DEVELOPMENT REVIEW COMMITTEE WAIVER REQUEST FORM

PROJECT NAME: SLACK PROPERTY, DUANE & TAMMY - WAIVER REQUEST

PROJECT NUMBER: 2003110019 APPLICATION: #26732

2.21.1.A - MAJOR SITE PLAN

9 DEPARTMENT: ENGDRN - STORMWATER REVIEW

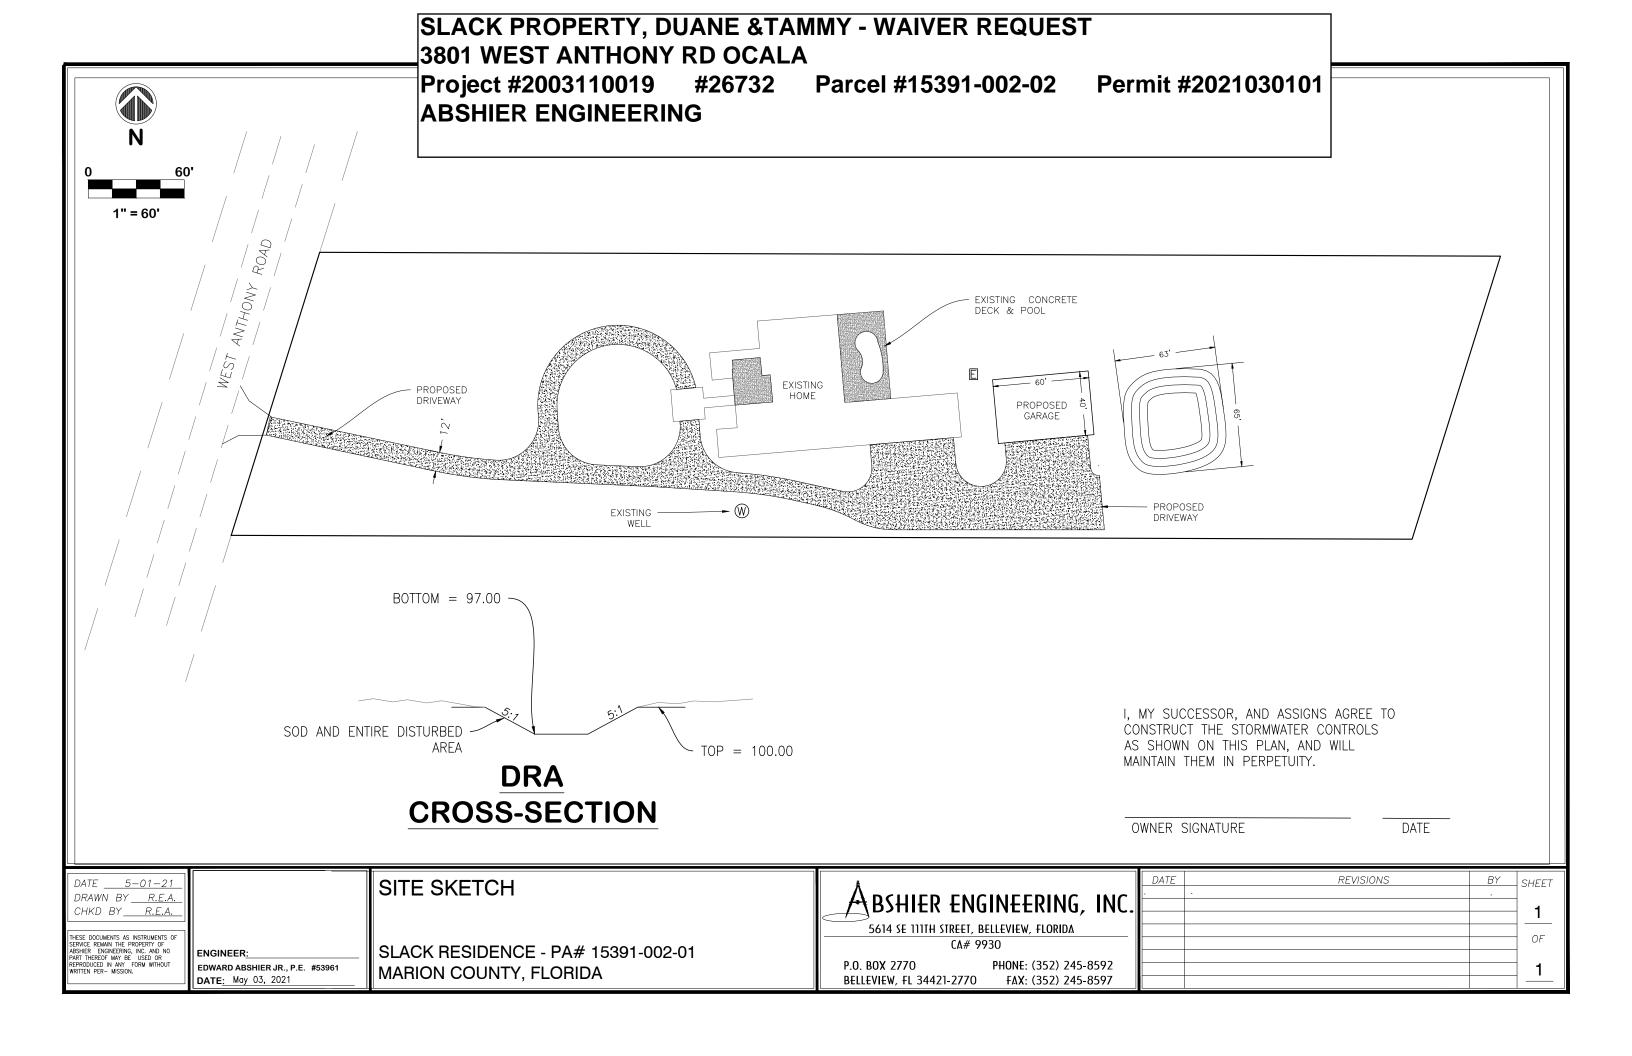
REMARKS: **CONDITIONAL APPROVAL**. Staff recommends approval subject to the following conditions: 1) a. The applicant must provide on-site stormwater control for the additional runoff from the new impervious areas. The plan by Ed Abshier, PE shows a portion of the new driveway (9,000sf) and new garage (2,400sf) will be constructed to drain to a new stormwater retention area. 2) A permit/inspection hold will be in effect until a sketch of the stormwater controls is provided to Stormwater and approved. 3) A Final Hold will be in effect until: a) Stormwater staff conducts a final inspection. Please note that all areas disturbed by construction must have vegetative cover established at time of final inspection. b) The applicant must provide a final sketch, noting the horizontal extents and volume capacity of the stormwater controls.

Note: The subject parcel is a 3-acre parcel (PID 15391-002-02) located off W Anthony Rd (County road). The existing impervious coverage is 9,359sf. The proposed driveway and garage is approximately 17,105sf for a total of 26,464sf. Staff recommends approval with conditions.
